GENEVA STEEL

Keigley Quarry
RFD #1 Box 20-B
Santaquin, Utah 84655

19 February, 1988

Re: Initial Review of Mining and Reclamation Plan, Keigley Quarry,
M/049/001, Utah County

<p>GENEVA WORKS U.S. STEEL CORPORATION</p>	<p>DRAWN <u>257</u> 1-19-88 CHECKED <u>DMH</u> 3-29-77</p> <p>DESIGN ENG. _____</p> <p>APPROVED _____</p>	<p>KEIGLEY QUARRY TYPICAL CROSS SECTION</p>	<p>SCALE: _____</p>	<p>DRAWING No. Y-6669-A</p>
--	---	---	---------------------	--

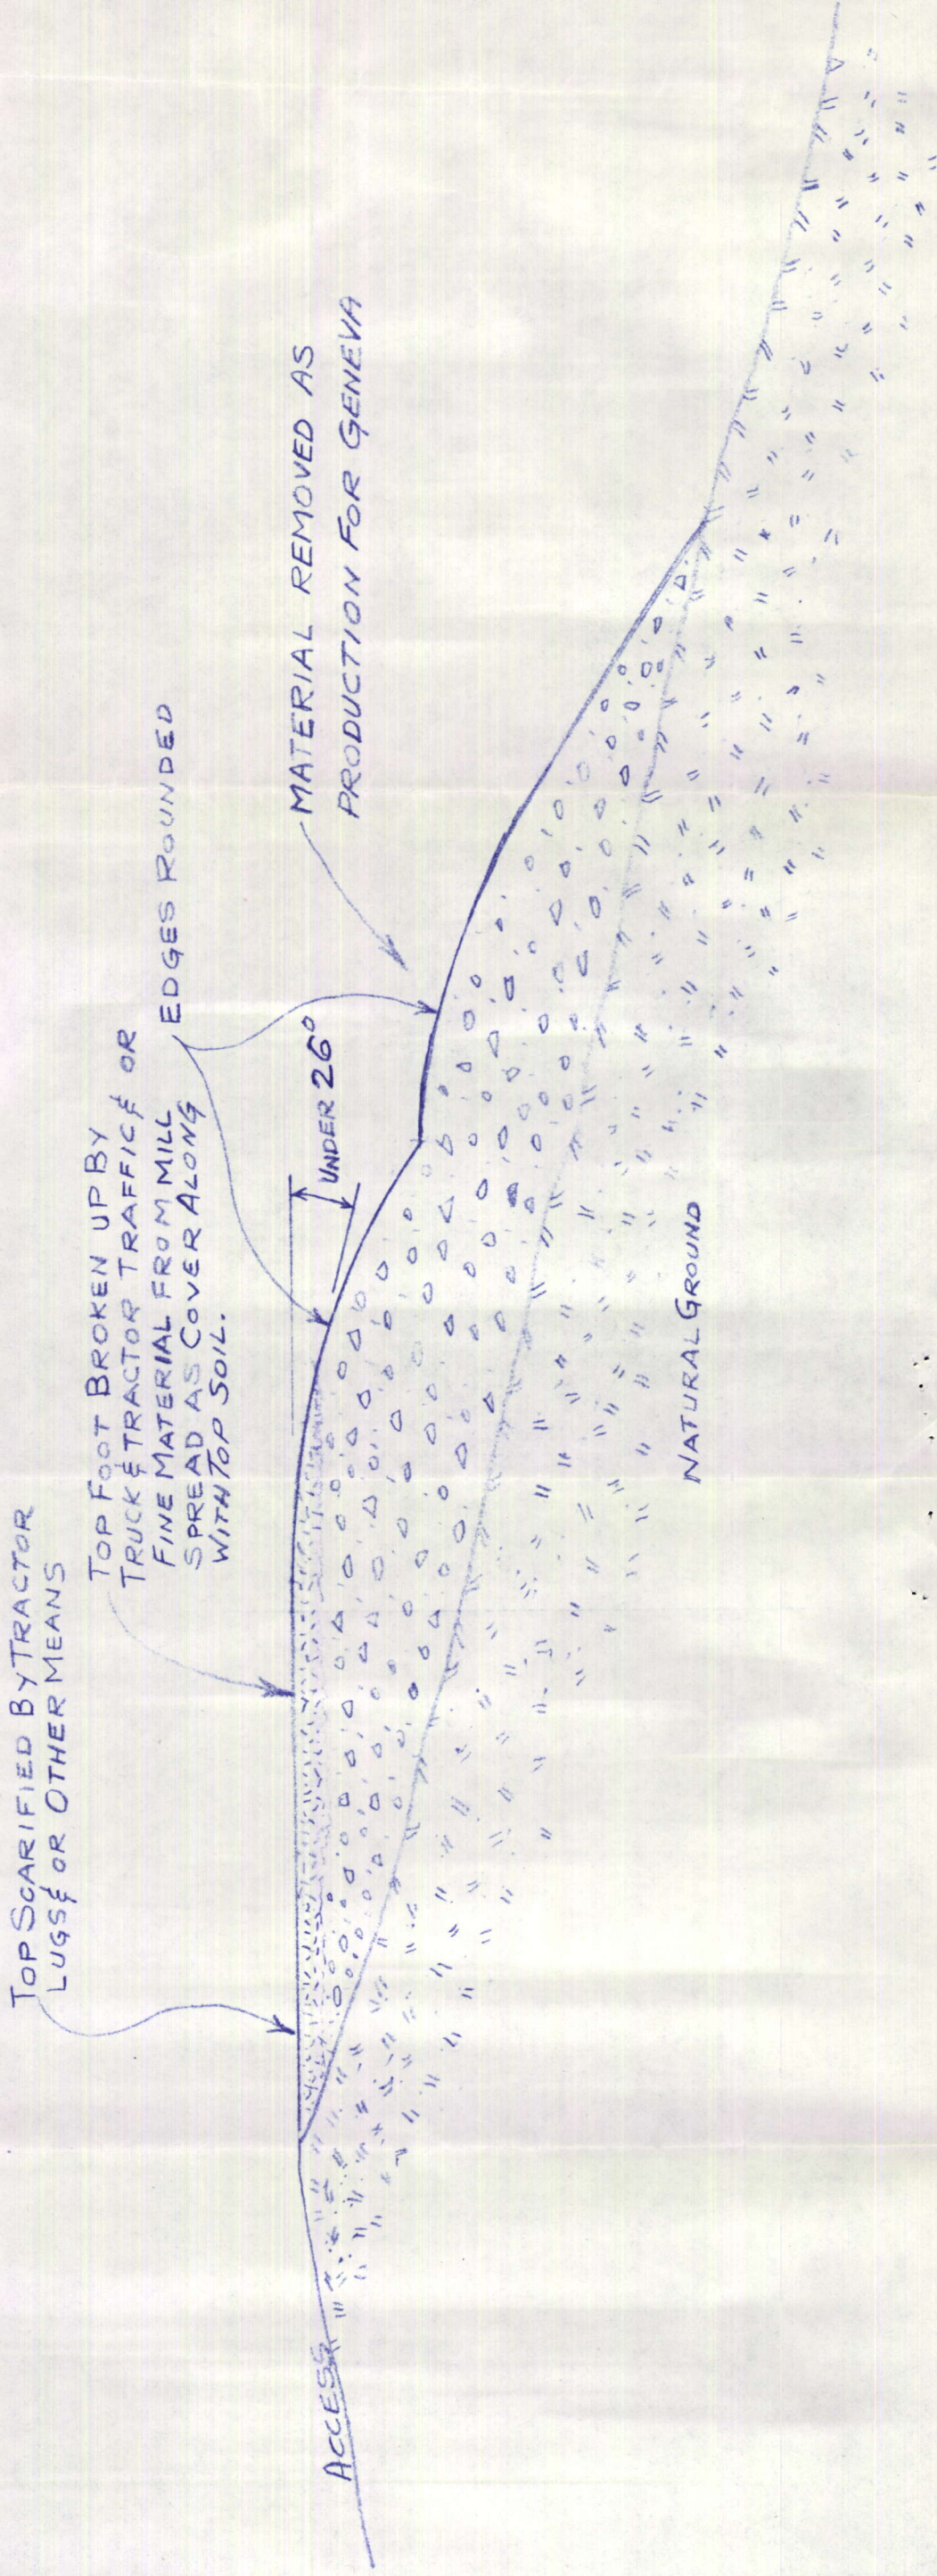
As in Section V, Item 3(b), we are submitting a new map, #Y6669-A, for your review. By removing a portion of the waste dump as production, in an orderly and planned manner we will be able to develop a two level dump that would allow us to meet the $26\frac{1}{2}$ degree slope you desire. This would provide the desired slope stability and erosion control for successful revegetation. The only problem that we could encounter would be where an outcrop or slope of the original ground is steeper than $26\frac{1}{2}$ degrees. We would request, at that time, an exception to the slope requirement for the exact area involved, as we do not feel it would be prudent to do the required drilling, blasting, etc., to reduce the profile to less than the original ground profile.

Y-6669

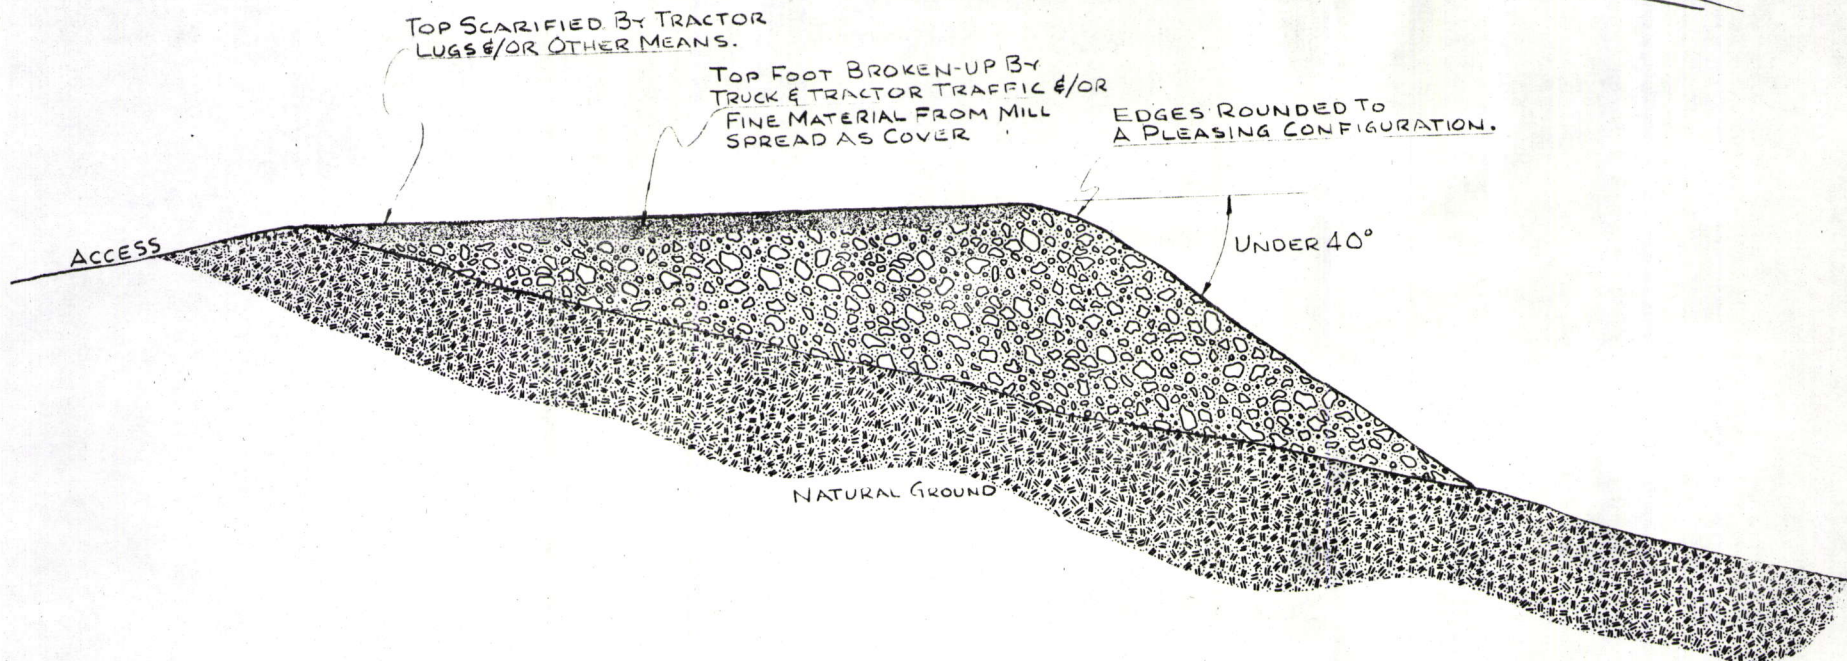
Item 3(b) - Backfilling and Grading - The dump configuration shown in drawing No. Y-6669, Typical Cross Section, Dump Regrading, Keigley Quarry, is unacceptable for final reclamation. Given the possibility that a major portion of the dump may not be consumed for processing as projected, Geneva must provide a written commitment to reduce the dump faces to a gentler slope. The Division recommends regrading the dump faces and all other disturbed areas to a 2(H):1(V) slope (26 1/2 degrees) or less in order to provide for erosion control, slope stability, and successful revegetation.
